GOLDEN GARDENS PLAY AREA RENOVATION

October 7, 2010

Concept

Concept Alternatives

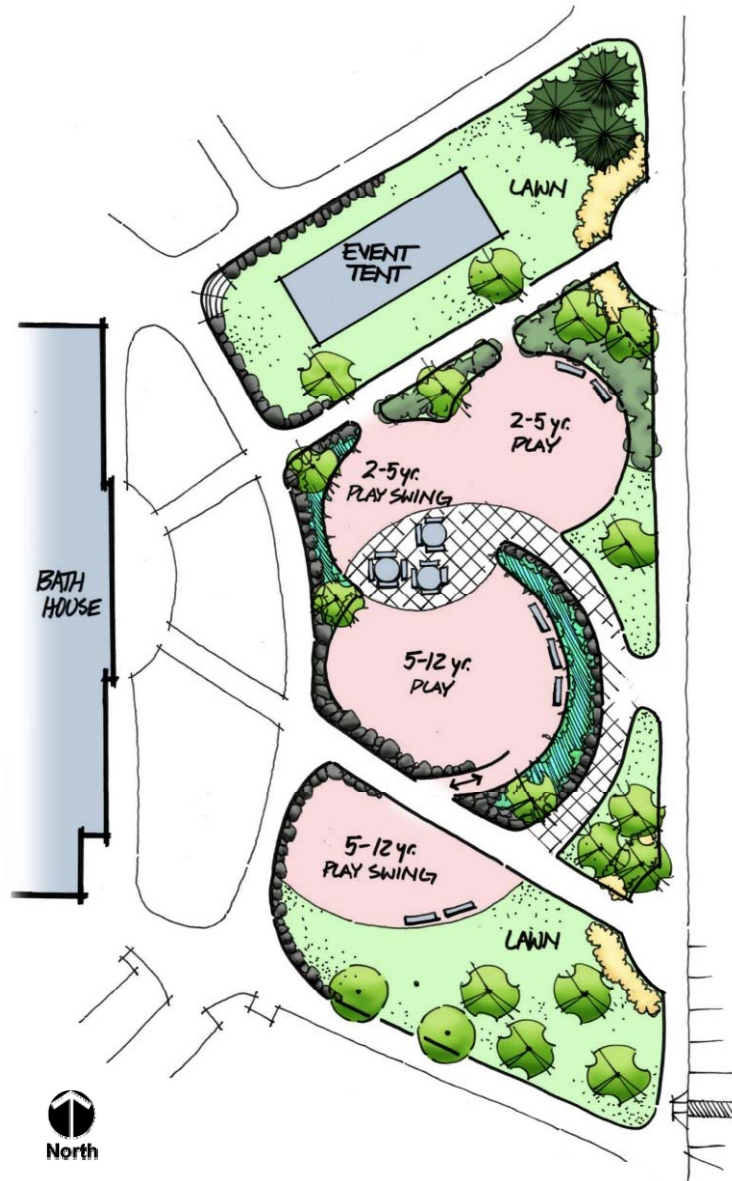
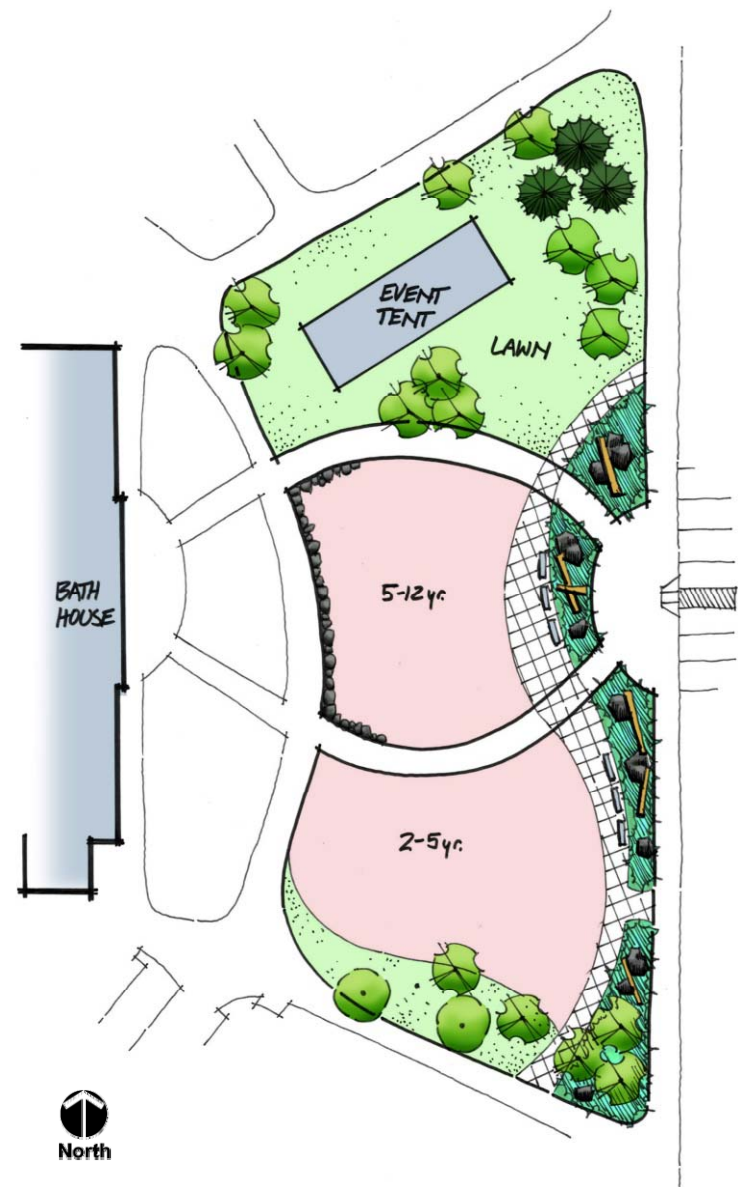
1. The Commission encourages the existence of breathing room between the building and play area to allow for normal functions to occur.

2. The design should present a stronger flow with more thought put into the path and their connections.

3. There is an unresolved relationship between the paths, curb, and parking lot in relation to ADA accessibility.

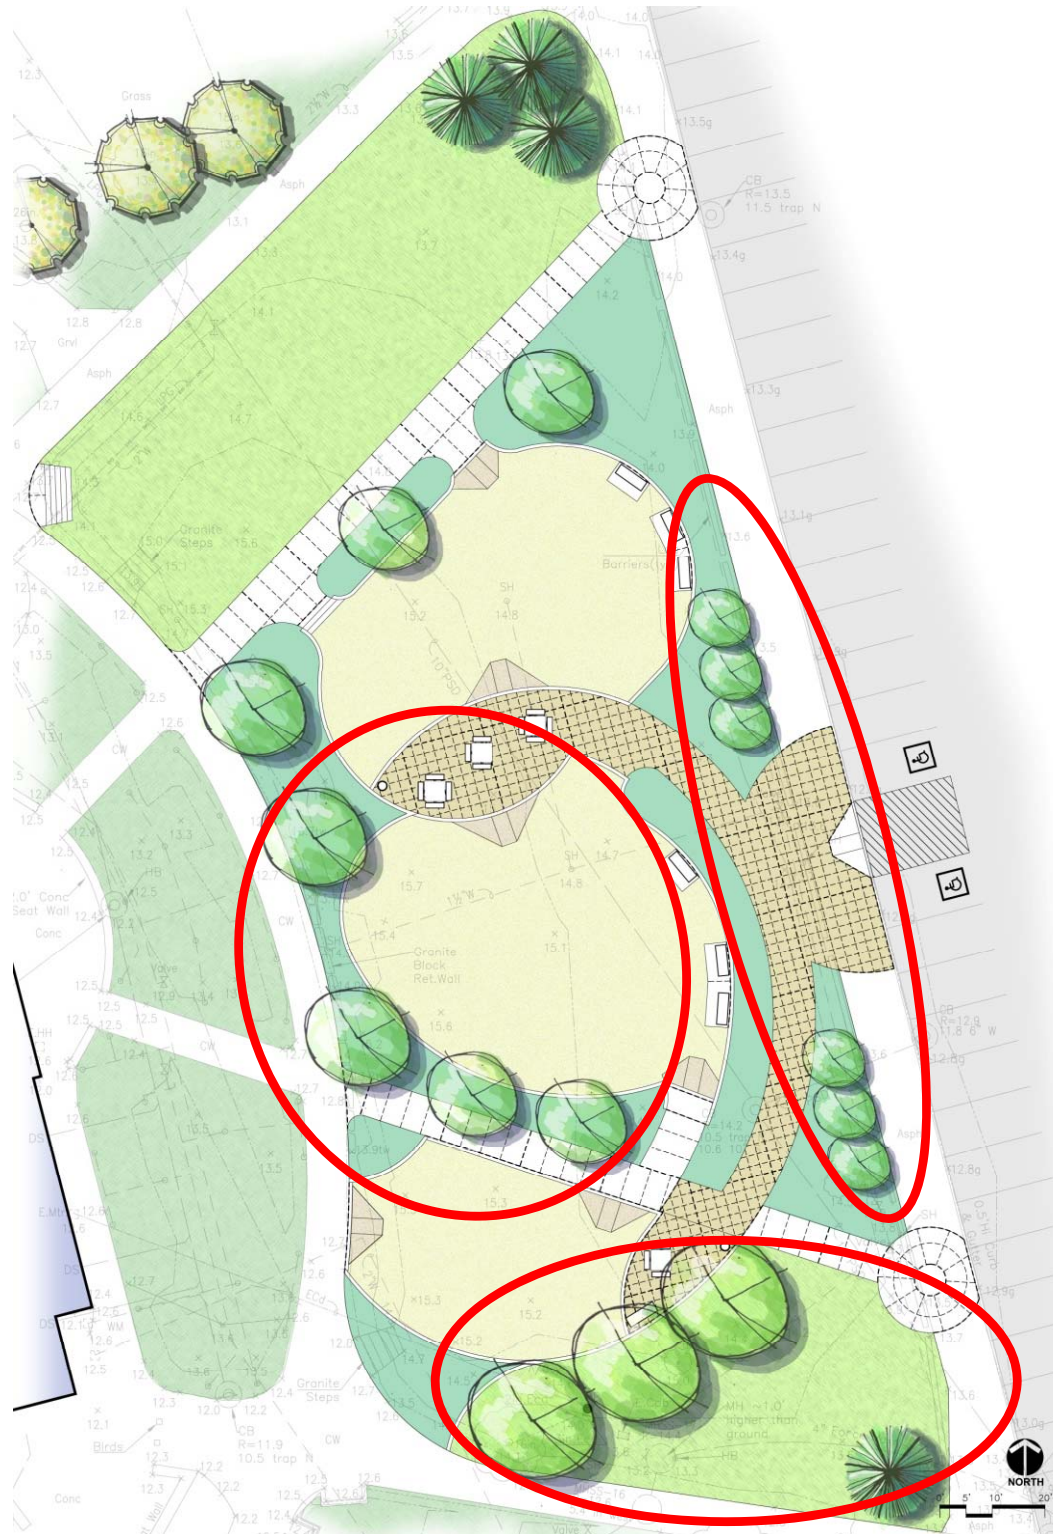
4. Consider adding a plaza-like space on the south east area that will allow placement of chairs and tables that will complement the kids play area.

Revised

Revised - Trees

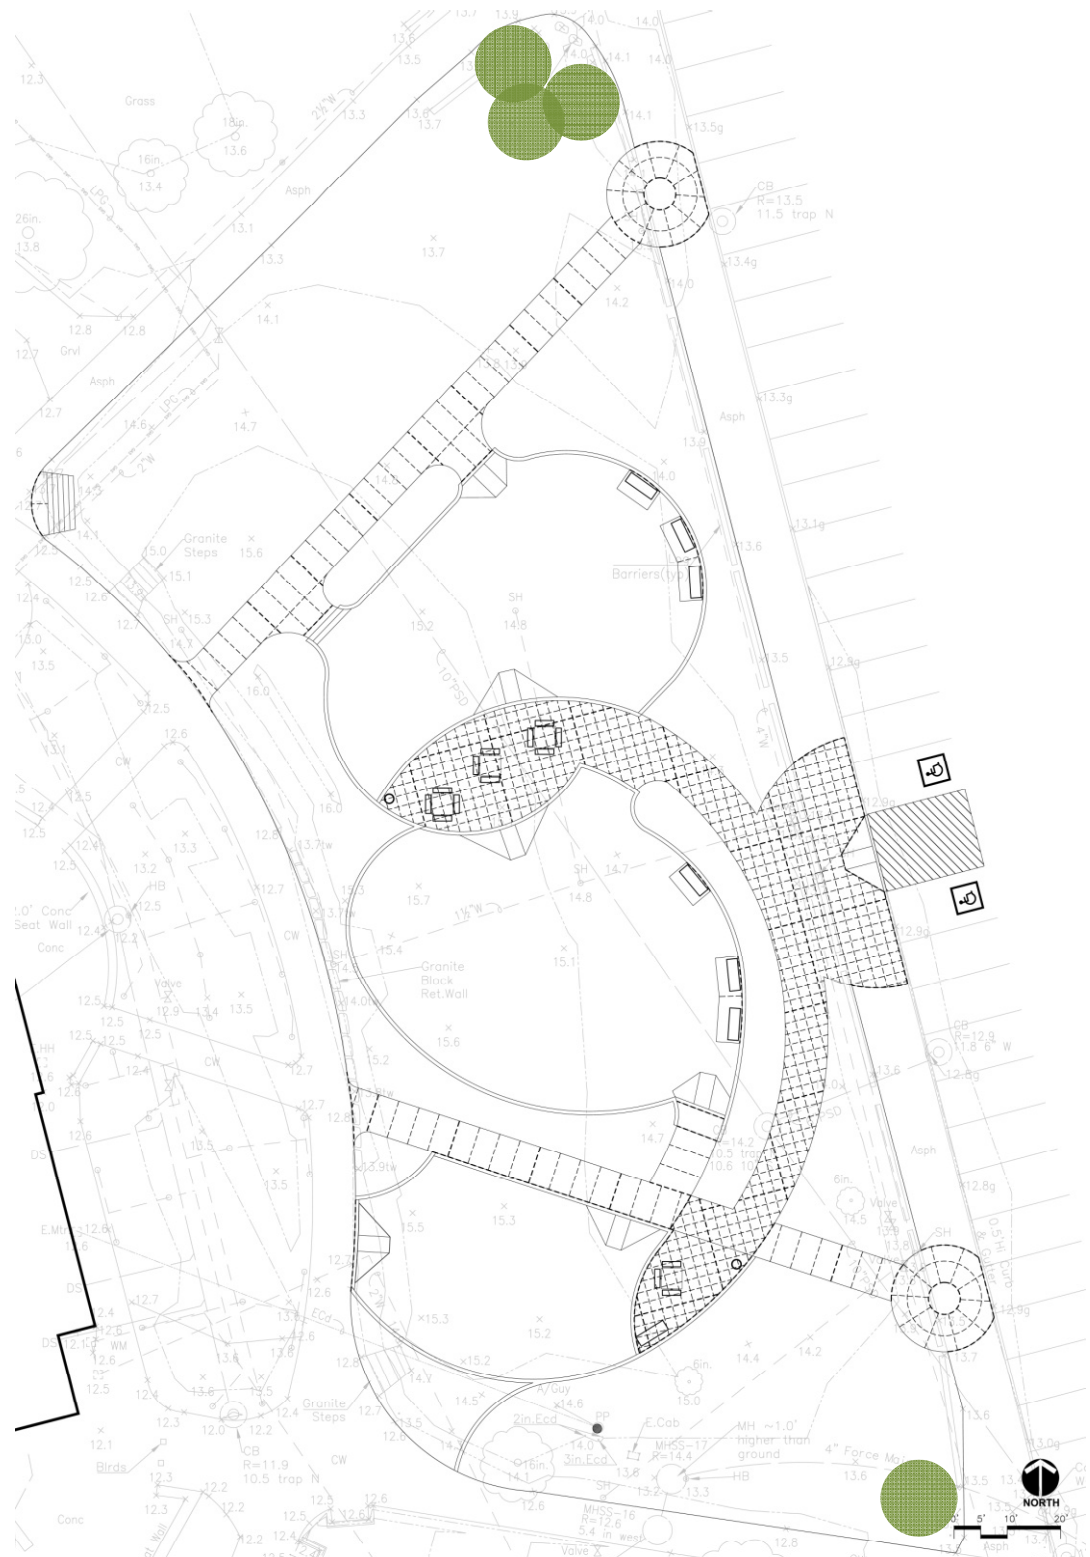
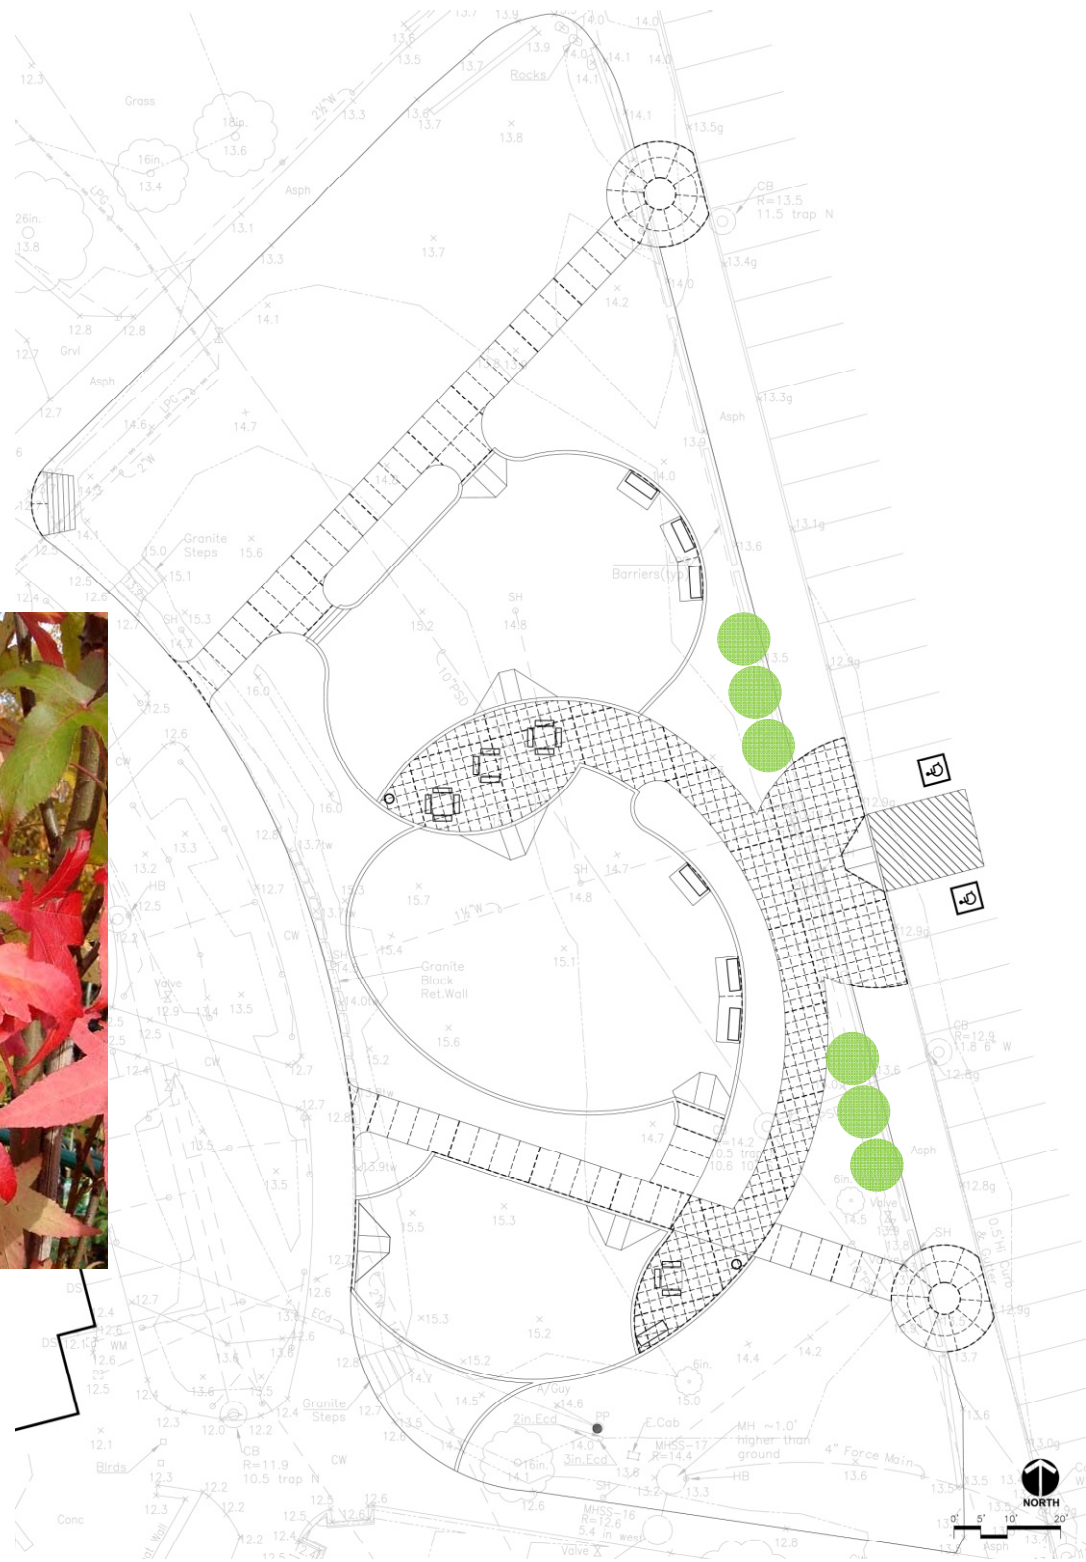
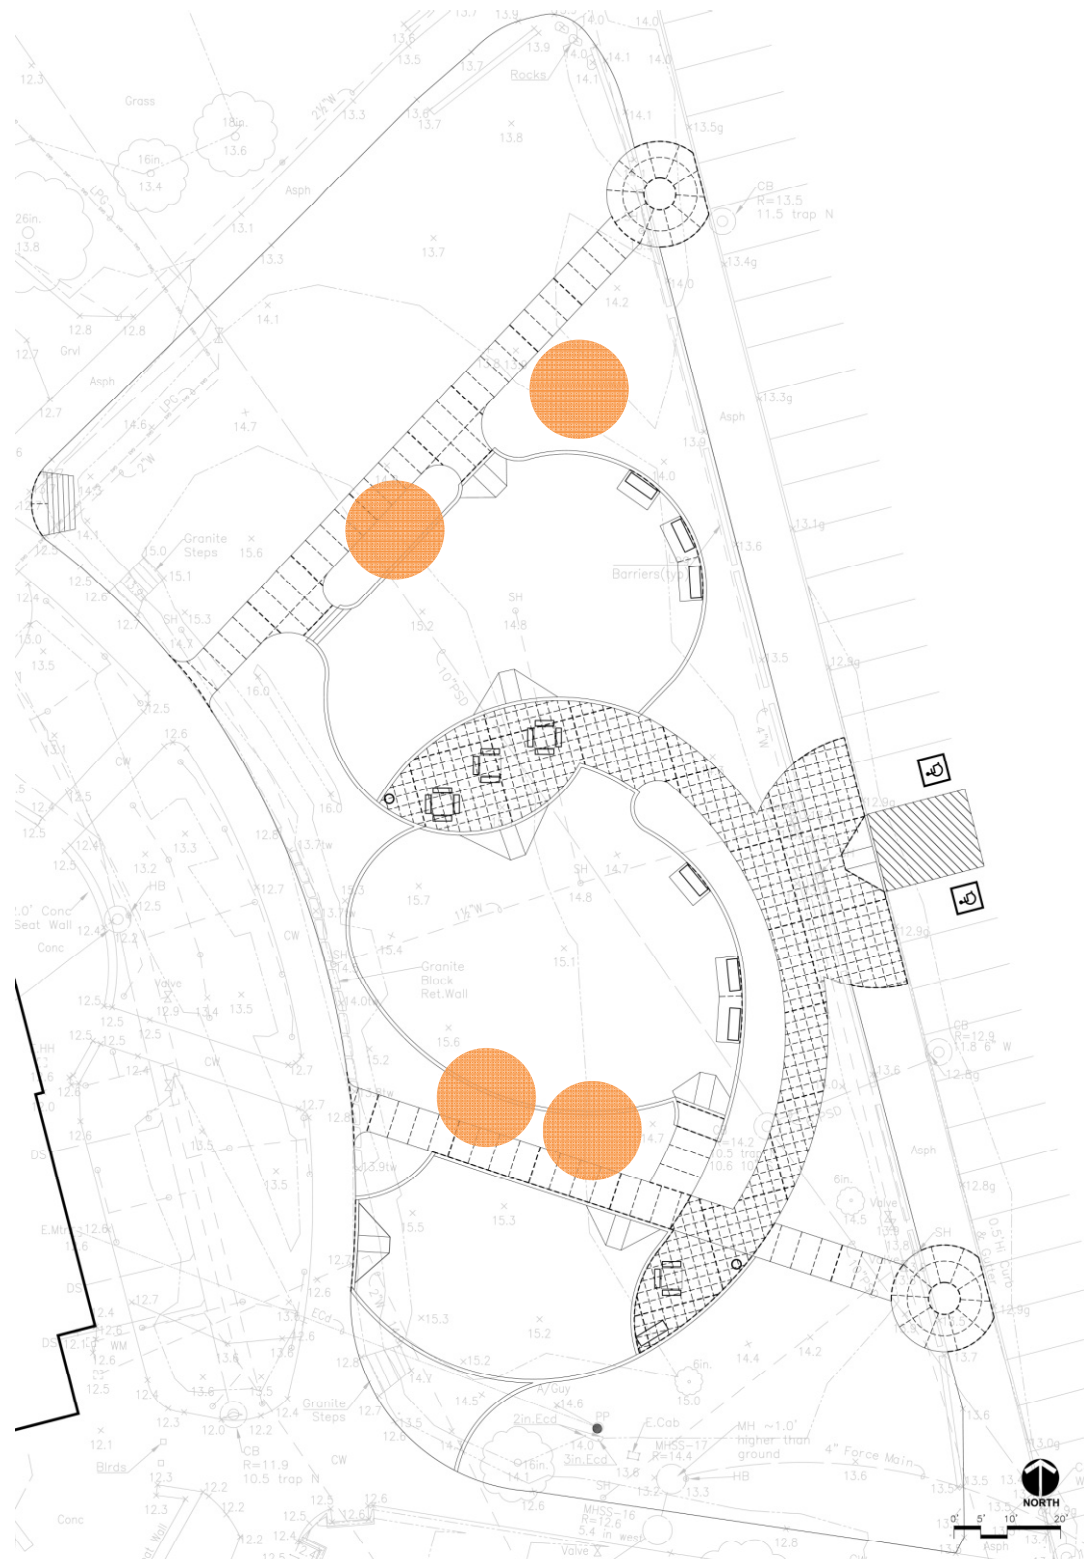
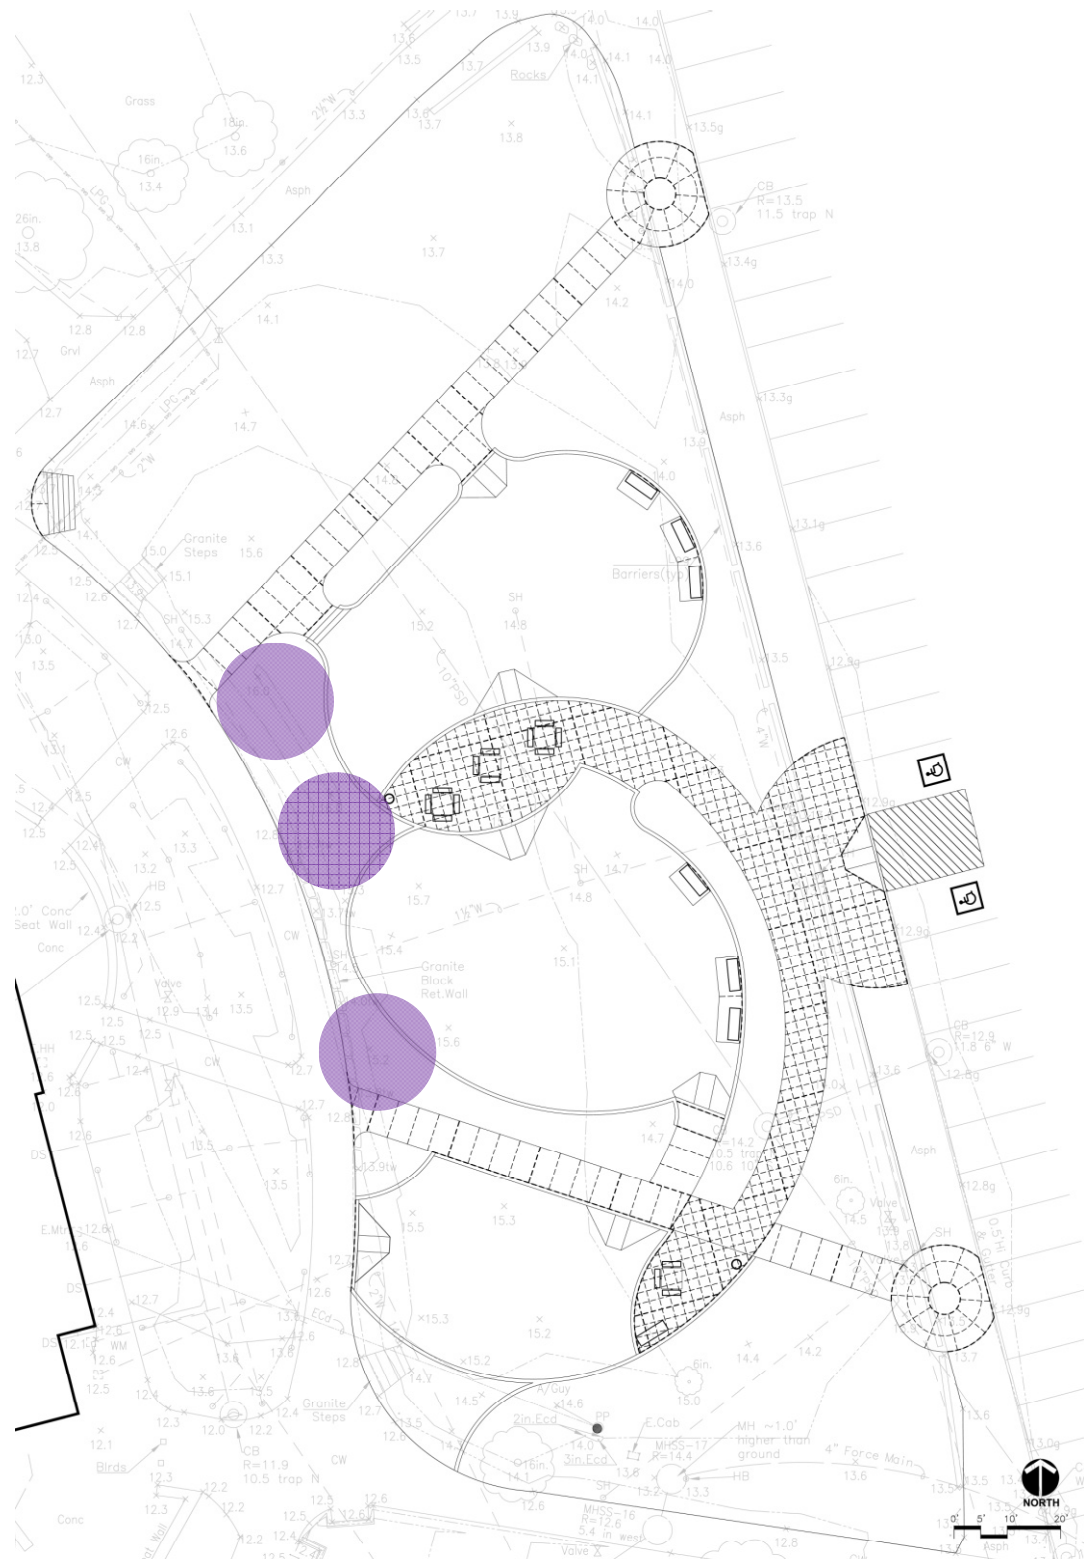
5. Consider the use of trees as well as other potential vertical elements as a way to the define spaces and create a progression of rooms.
